SUBMISSION SYDNEY METRO WEST

Critical State Significant Infrastructure Application

Rail Infrastructure, Station, Precincts & Operations EIS

MAY 2022

Figure 1: Section illustrating building envelope applicable to land to the north of new town square on eastern side of Great North Road and expanded Fred Kelly Place on western side of Great North Road (Part F, Section D, page F-157)

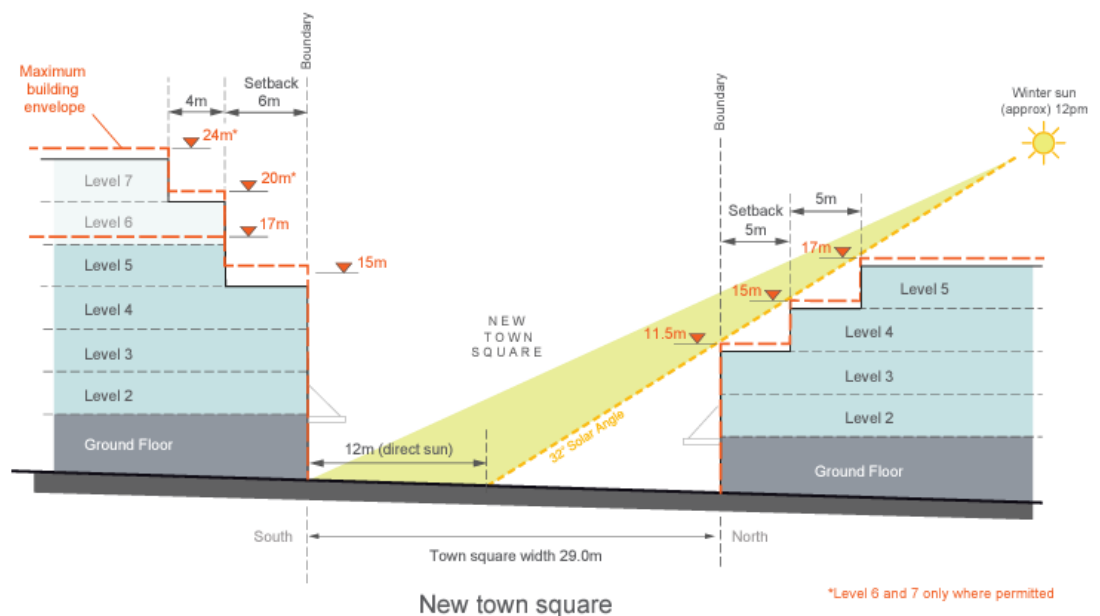
These objectives are reinforced by development controls in the form of building envelopes (heights and upper-level setbacks) that aim to ensure future development to the north of Fred Kelly Place protects solar access to this public open space (see Figure 1).

It is apparent that the building envelope contained within the EIS will result in more overshadowing of Fred Kelly Place than would occur with a development that was compliant with the applicable development controls. This impact appears to occur due to the overall height of the building and the lack of upper-level setbacks above the third and fourth floors.

- The Critical State Significant infrastructure application should be revised to ensure that the proposed building envelope to the north of Fred Kelly Place does not create any additional overshadowing to that contemplated by the *Canada Bay Development Control Plan*.
